Application No.	Applicant(s)			
	10/591,041	KLEIN, VOLKMAR			
Office Action Summary	Examiner	Art Unit			
	ATIF H. CHAUDRY	4156			
The MAILING DATE of this communication app Period for Reply	ears on the cover sheet with the c	orrespondence address			
A SHORTENED STATUTORY PERIOD FOR REPLY WHICHEVER IS LONGER, FROM THE MAILING DA - Extensions of time may be available under the provisions of 37 CFR 1.13 after SIX (6) MONTHS from the mailing date of this communication. - If NO period for reply is specified above, the maximum statutory period w - Failure to reply within the set or extended period for reply will, by statute, Any reply received by the Office later than three months after the mailing earned patent term adjustment. See 37 CFR 1.704(b).	ATE OF THIS COMMUNICATION 36(a). In no event, however, may a reply be tim vill apply and will expire SIX (6) MONTHS from cause the application to become ABANDONE	lely filed the mailing date of this communication. (35 U.S.C. § 133).

DETAILED ACTION

Fig.1

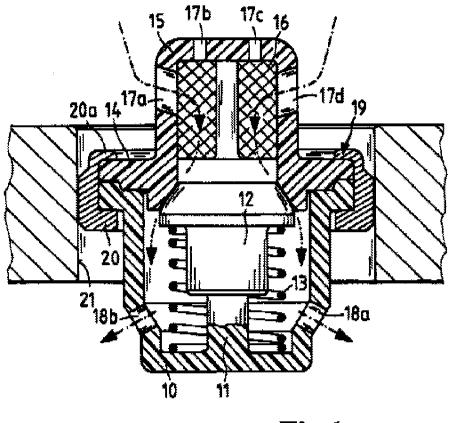
3. Regarding claim 1, Hengesbach discloses (fig 1) a valve housing 1 with an interior fluid passage along its axis, a seat element 2 with valve seat 11a detent element 16 movable against a spring 23 wherein the valve seat can be adjusted axially to adjust the closing force of the spring.

4. Regarding claim 2, Hengesbach discloses a displacement device 9 actuable from exterior of the valve for axial adjustment of the valve seat.

- 5. Regarding claim 3, Hengesbach discloses seat element 2 which is axially movable in the housing 1 and therefore can be described as a piston and is coaxial with the interior passage.
- 6. Regarding claim 8 a guide element 17 with fluid passages 18 which guide the valve head 12 in axial displacement.

9. Regarding claim 9, Hengesbach discloses a guide pin 16 which is attached to the valve head therefore is not the valve head is not moveable with respect to the guide pin. Orth (fig 1) teaches a guide pin 11 which is fixed and the valve body 12 slides axially on the guide pin. It would have been obvious to a person of ordinary skills in the art to have substituted the valve guide arrangement of Hengesbach with that of Orth as an alternate method known in the art. The claim would have been obvious because a
